WHAT'S THE ANSWER?

CORRECTIONS for "Underwater Interlocking" Circuits

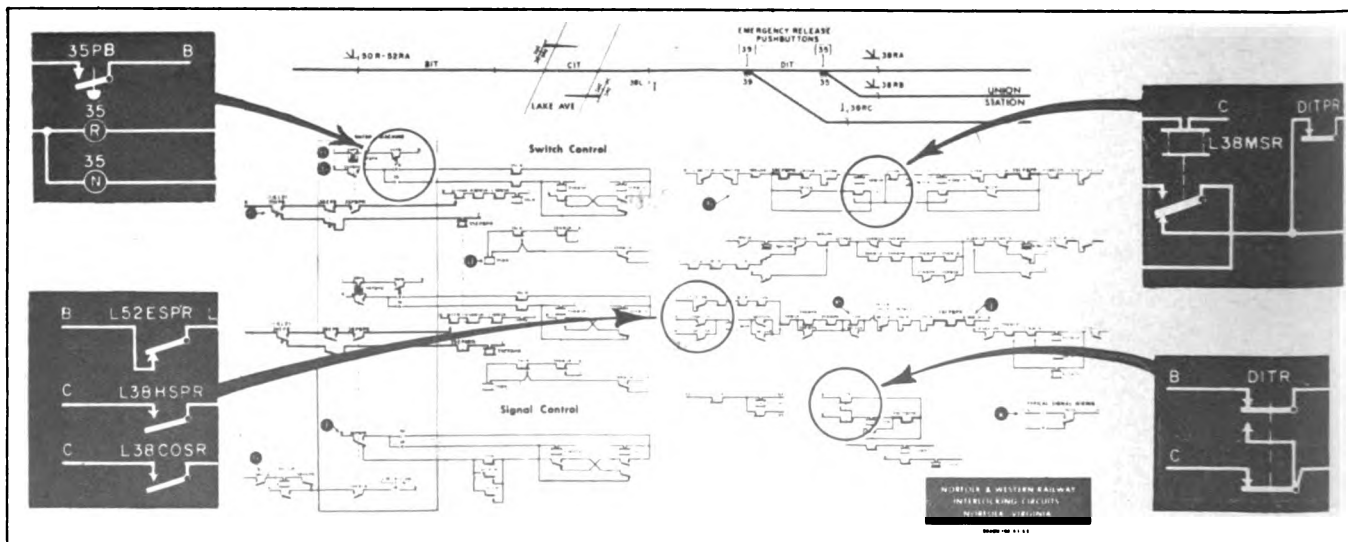
The fold-out circuit plan in the January issue, page 22, regrettably contained four errors. These errors were spotted by observant readers who called them to our attention. They are: (upper left) lower lever contact should be **35N**, not 35L; (lower left) left side connections to relay L38HR should lead to common, "**C**", not to "B"; (upper right) stick contact on relay L38MSR should be

making its **back** contact, not its front contact; and (lower right) left side connection to relay DITPR should lead to "**C**", not to "B". These corrections have been made the same size and color as the original circuit plan, and the squares may be cut out and pasted on top of that plan to provide a corrected plan of N&W interlocking circuits.
